**ADDENDUM NO. 3
IRONDALE PUBLIC LIBRARY**

CITY OF IRONDALE

Project Name: Irondale Public Library
Project No: CWA Project No. 2022-08

A4.12

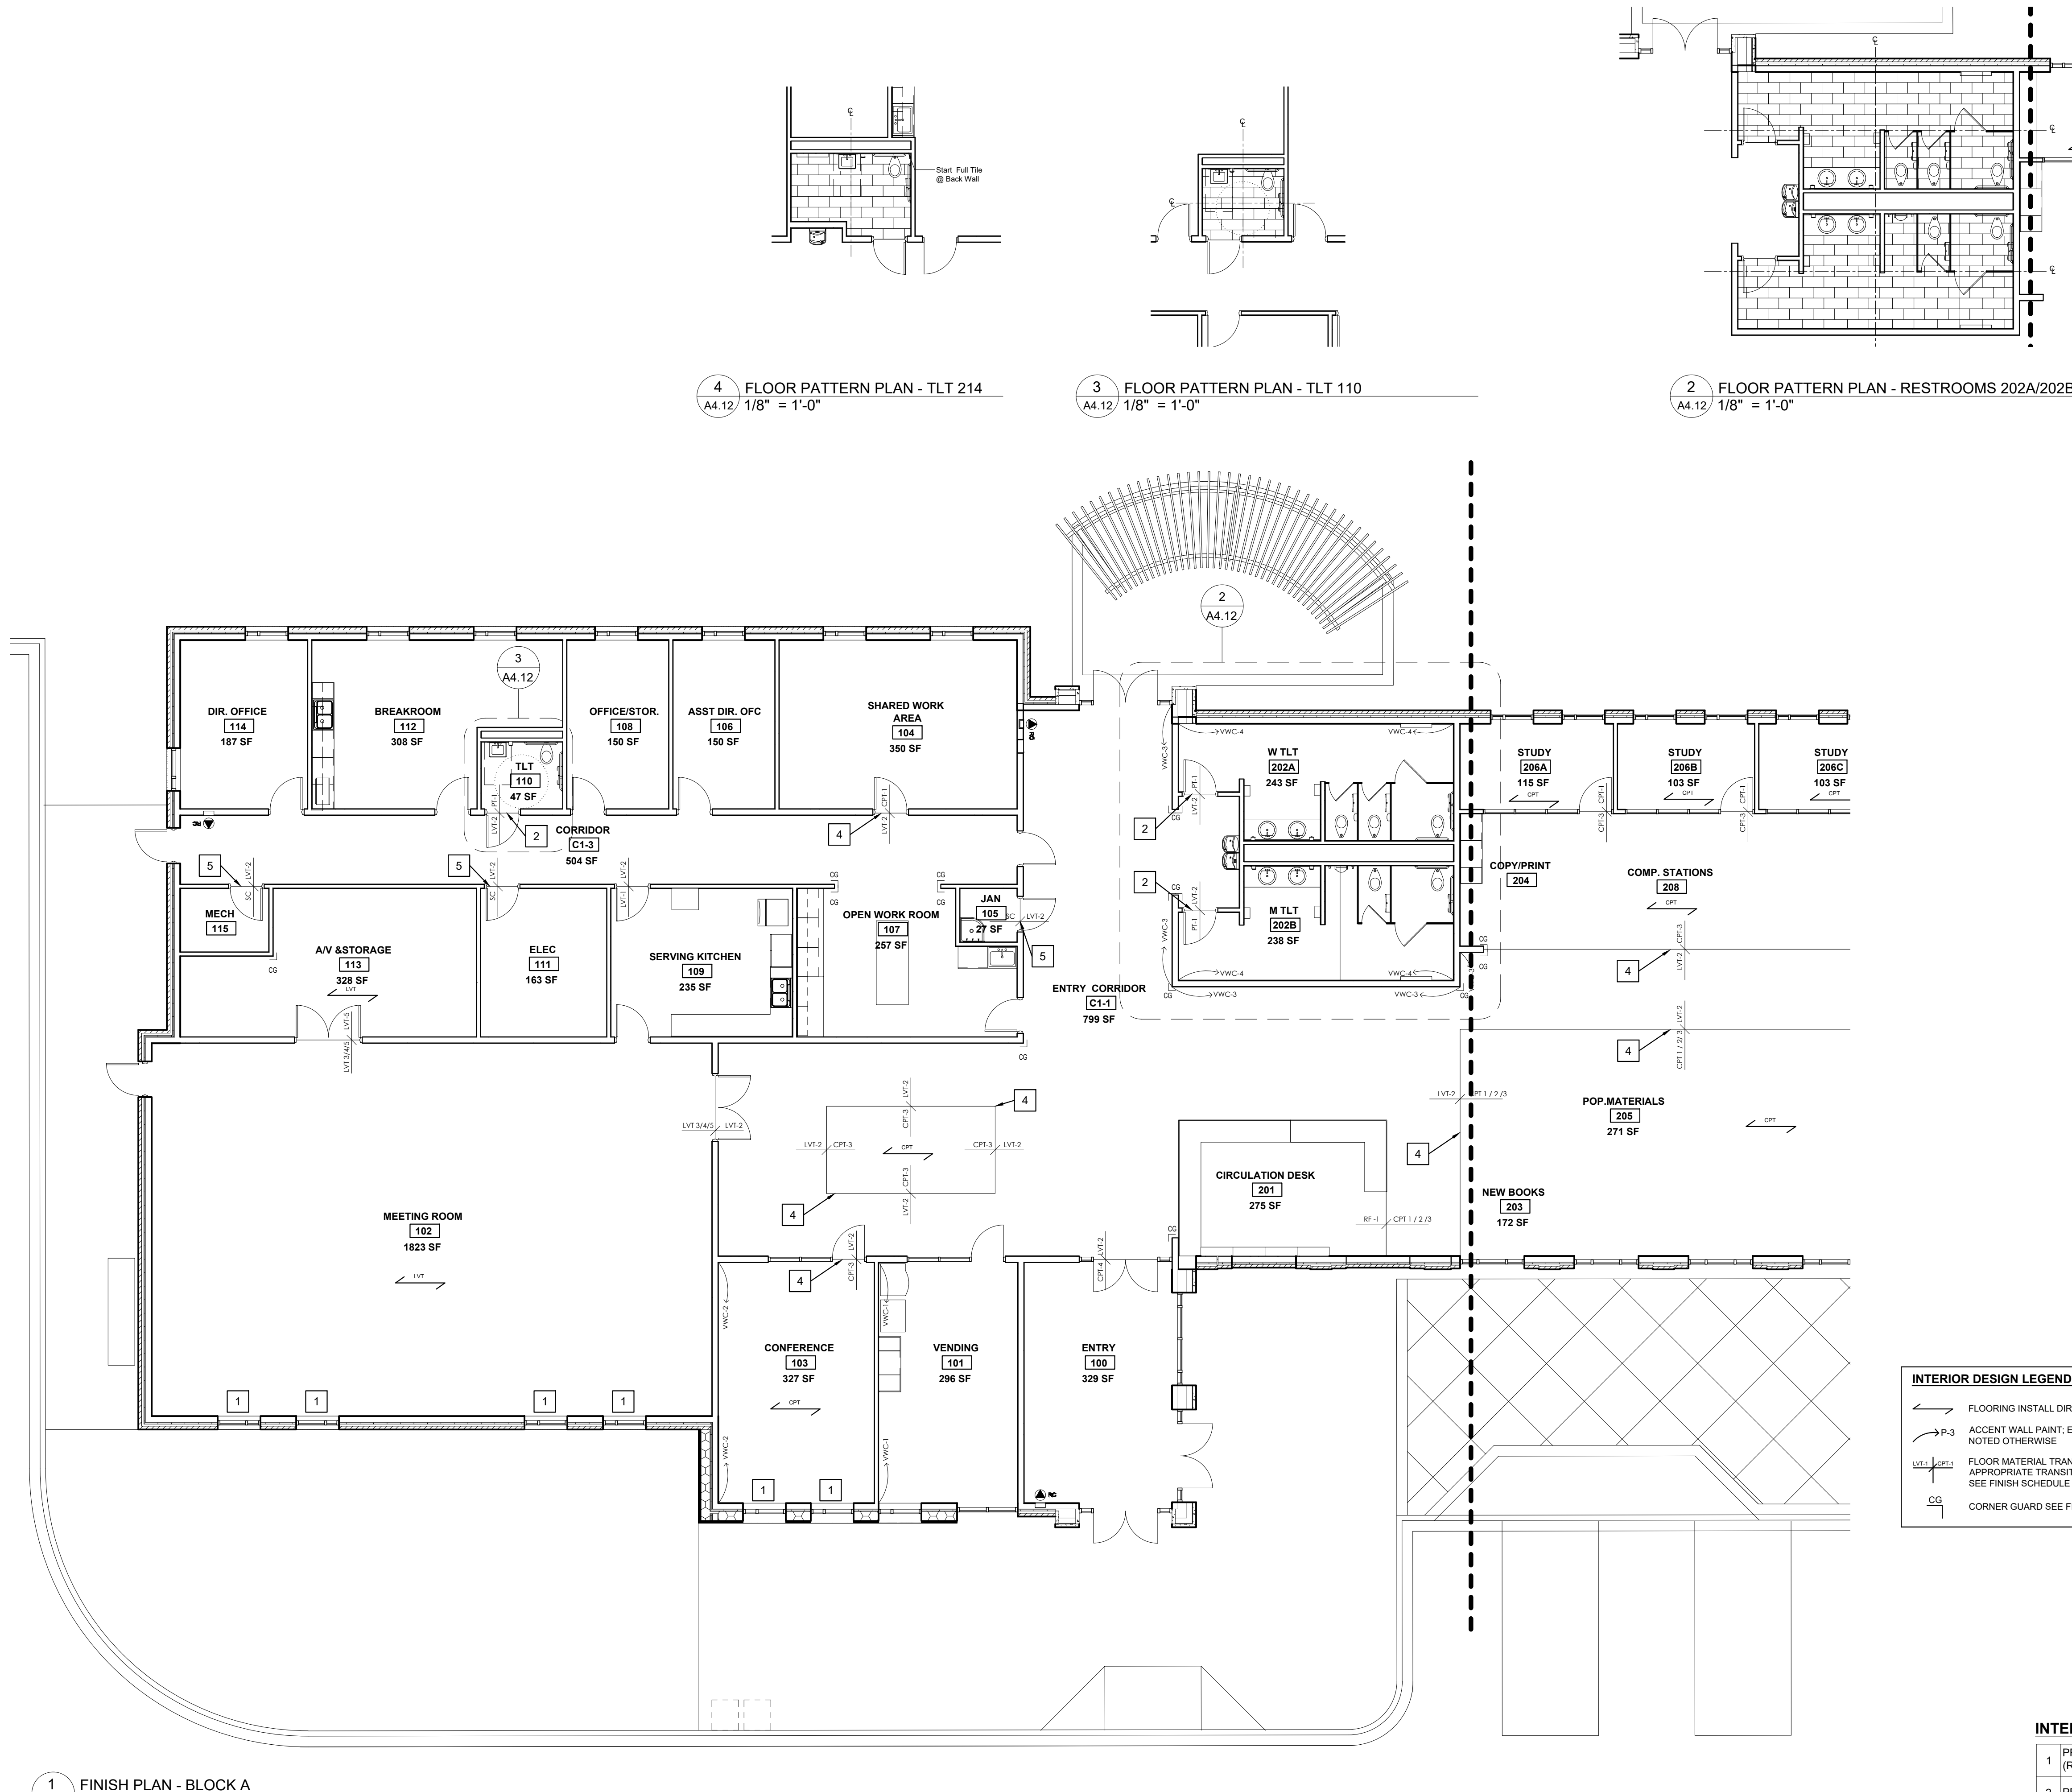
1. Sheet A4.12 and A4.13:
 - a. Reprinted sheets due to a text printing error
 - b. Corner guards shown, Keynote Legend shown, and finish designations on plans

Response: This is acceptable.
15. Spec 102600 does not show the length of the corner guards to be used. Floor plans A2.01, A2.10 & A2.11 do not show corner guard locations. Are we to assume corner guards will be required at all outside corners.

Response: Provide 5'-0" tall guards, mounted 6" above floor. See attached re-issued sheets A4.12 and A4.13.
16. Are the boxes near the sink in Restrooms 202A and 202B hand dryers. Will there be hand dryers in bathrooms 110 & 214.
